**TRANS/WP.15/2001/13
31 January 2001**

DOUBLE SHELL ALUMINIUM VESSELS FOR CLASS 2 GASES

Subject: Large Vacuum Insulated Transport Equipment for Cryogenic Liquids
(Class 2 , Gases Liquefied by refrigeration) : Minimum equivalent thickness
to ADR 21x 127 (3) and (4) (Impact safety level of tank shells)

Transmitted by International Tank Container Association (ITCO)

Change Of Proof Stress With Temperature For Extrusions

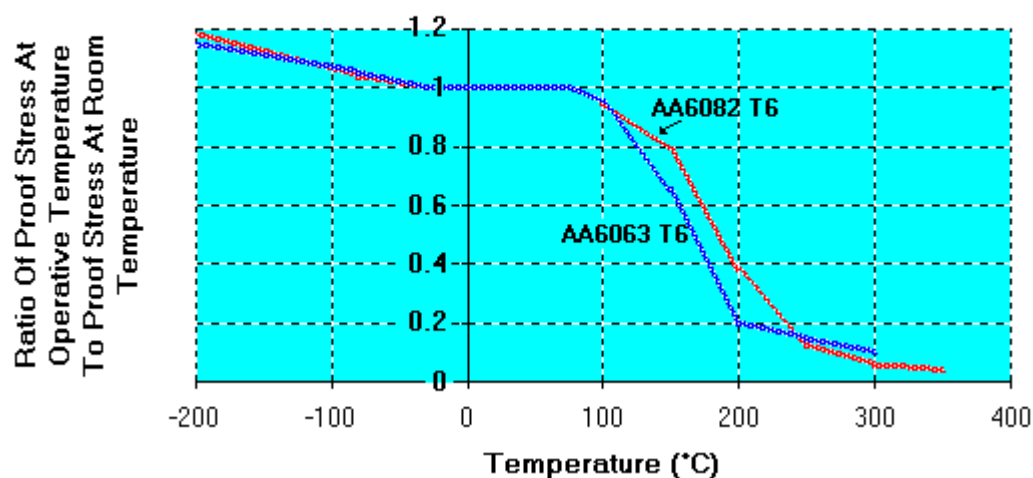
As the temperature falls below 0°C the ultimate strength (R_m) and the yield strength ($R_{p0.2}$) increase slightly for all aluminium alloys (see figure). The elongation will for the non heat-treatable alloys increase while it will remain at nearly the same level as at room temperature for the heat-treatable alloys.

As can be seen from the diagram, the properties of materials can increase by some 20% under

operating conditions at low temperatures. The most widely used distribution equipment for refrigerated liquids operate in the regions of -180°C to -196°C which utilises much of these increased mechanical properties. Although these properties should not necessarily be considered in any pressure calculations, this unique improvement in proof stress is of significant contribution to impact loading on the vessel.
